Hope Creek Generating Station

Offsite Dose Calculation Manual (ODCM)

Revision 30

Revision Summary

FIGURE 1.1 AREA PLOT PLAN OF SITE

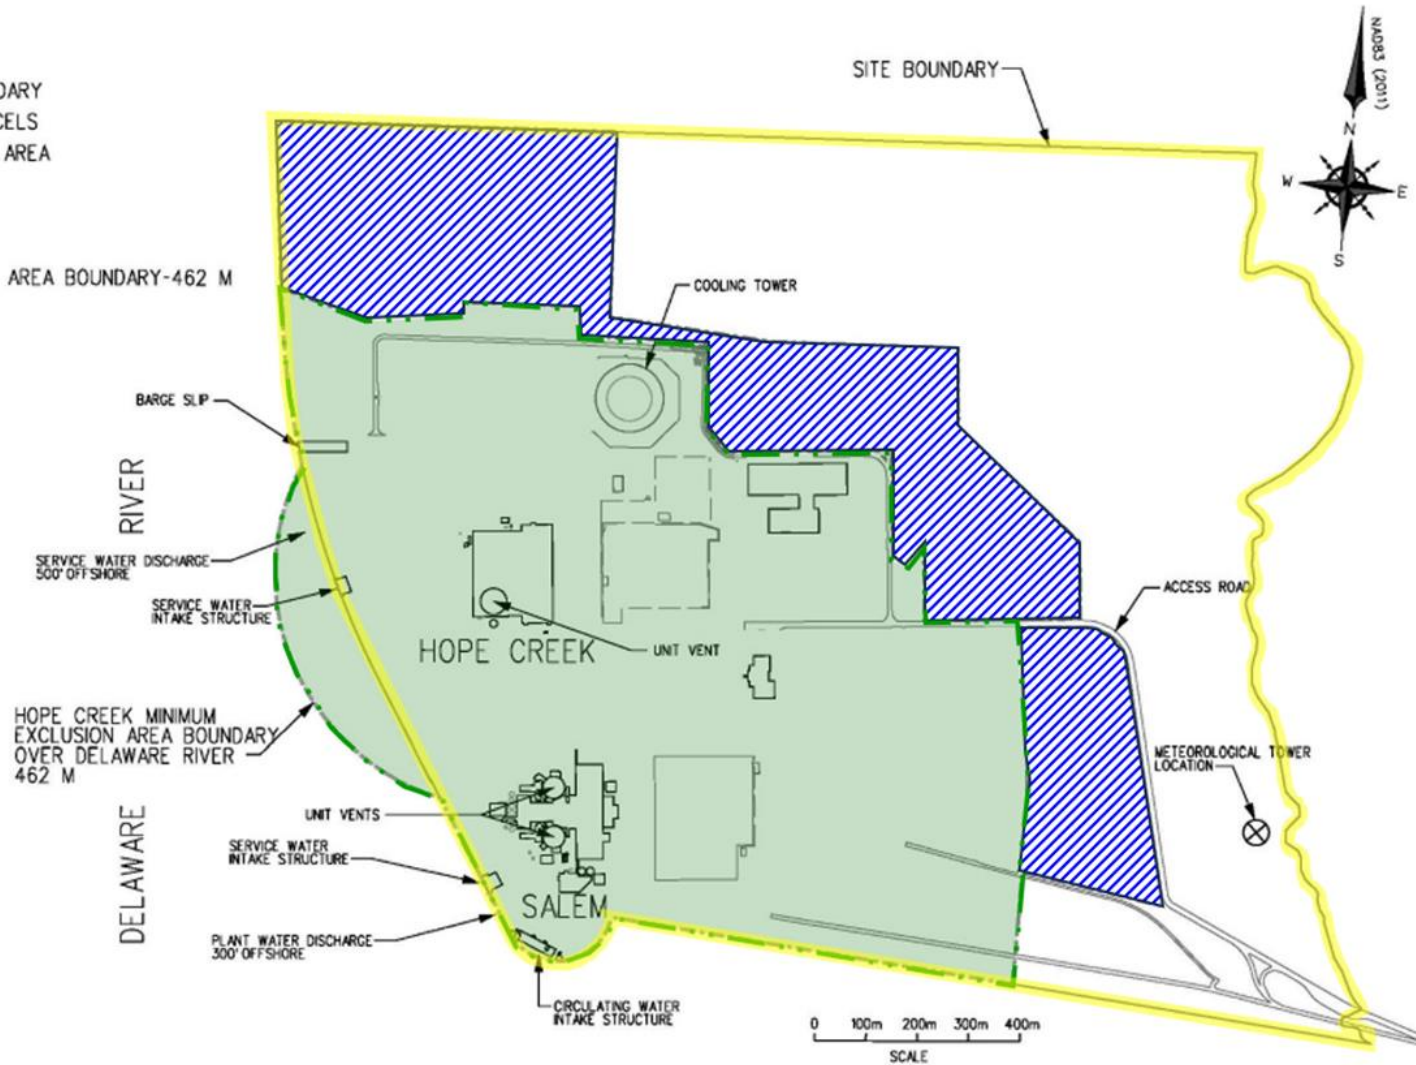
17.	10 24, 28, 29, 30, 33, 34, 36, 50	<p>Moved Figure 5.1-1 to the end of Section 1 Definitions. Renamed Figure to Figure 1.1. New map showing by color the Site Boundary, NJWP Parcels, and the Exclusion Areas.</p> <p>Updated document to point to Figure 1.1</p> <p>Justification: Section 5.0 Design Features was eliminated from the ODCM as not needed. That section is in Tech Specs and is overriding. The Figure 5.1-1 name changed to Figure 1.1, because the figure was moved from Section 5 (which is deleted) to Section 1 (Definitions). The map was updated</p>	Editorial

Item No.	Rev. 30 Page No.	Description of Change	Type of Change
28.	47	<p>Deleted Section 5.0 Design Features</p> <p>Justification: The figure showing the unrestrictive areas and site boundary was updated and moved to Section 1.0 Definitions.</p>	Editorial

FIGURE 1-1 LIQUID RADWASTE TREATMENT AND MONITORING SYSTEM

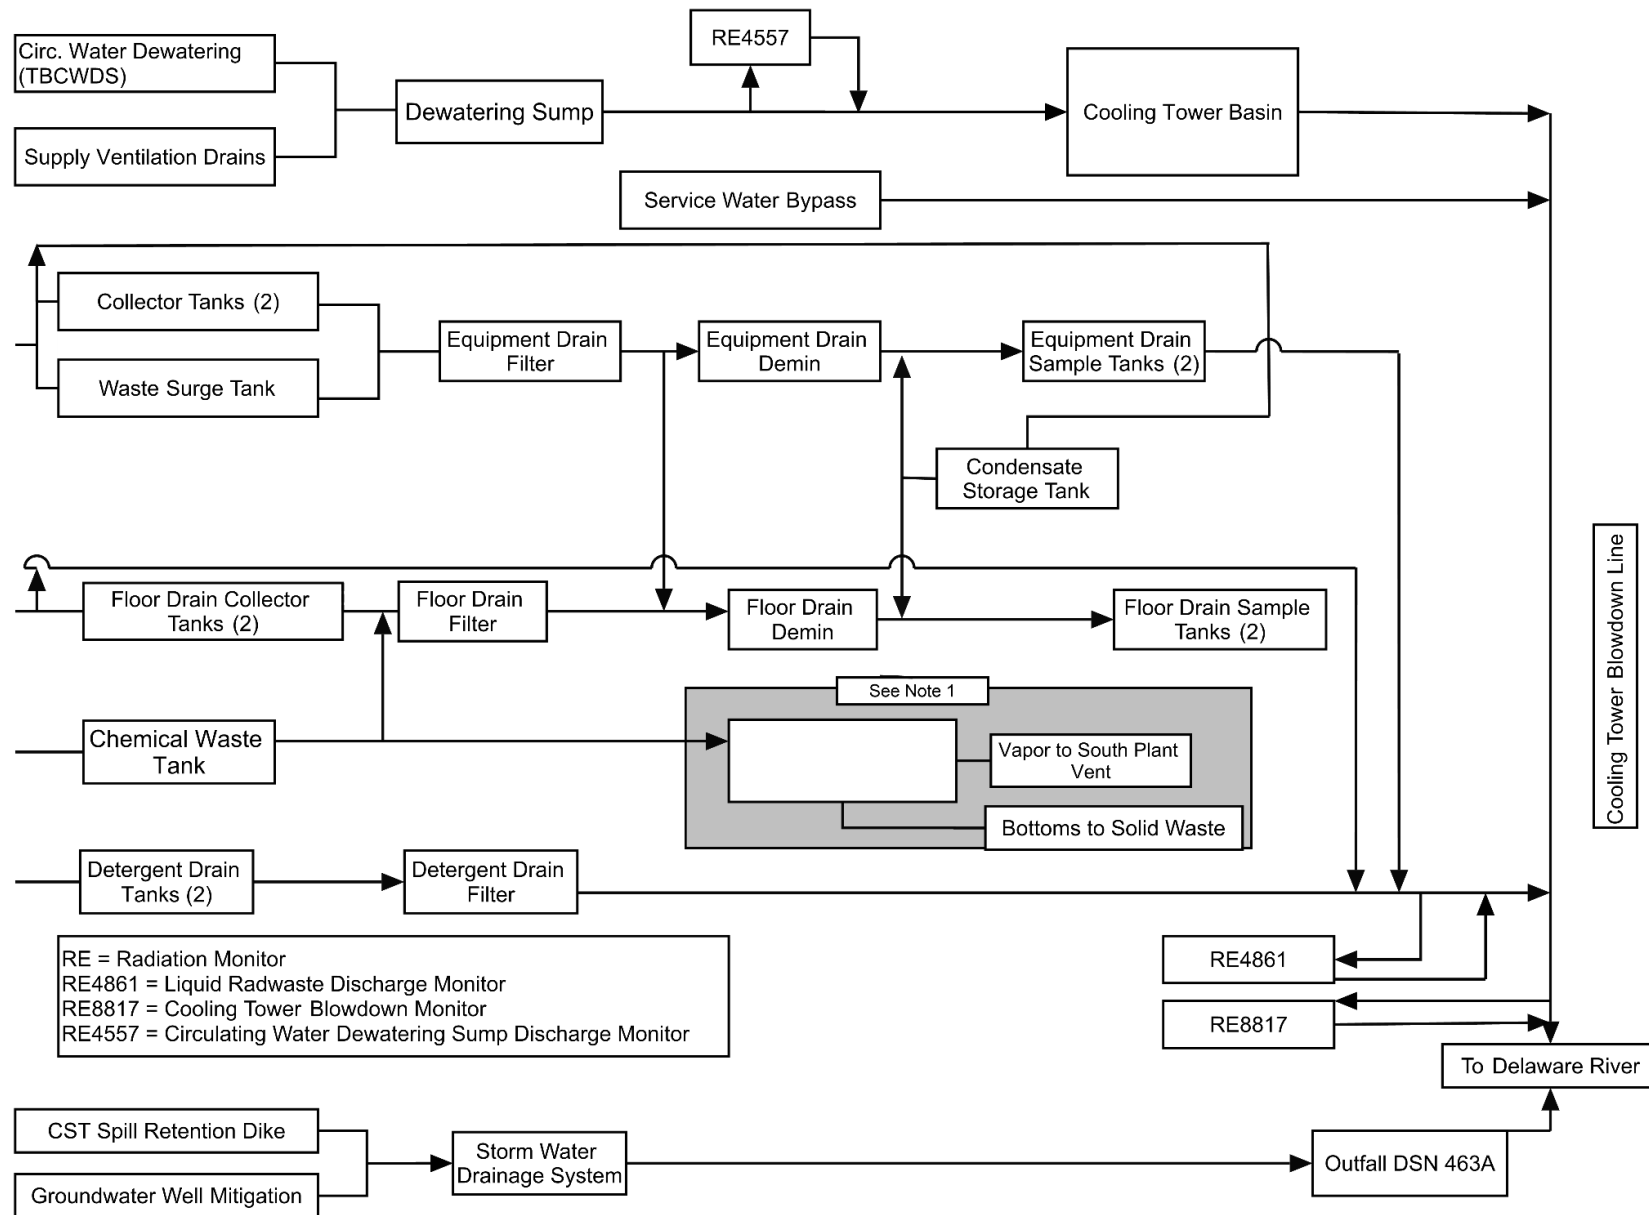
Item No.	Rev. 30 Page No.	Description of Change	Type of Change
39.	69	<p>Updated Figure 1-1 to show correct discharge path of the Condensate Storage Tank to either Equipment Drain Sample Tanks or to the Floor Drain Sample Tanks through the RE4861 radiation Monitor.</p> <p>Justification: Correction to figure to properly reflect discharges from the CST.</p>	Editorial
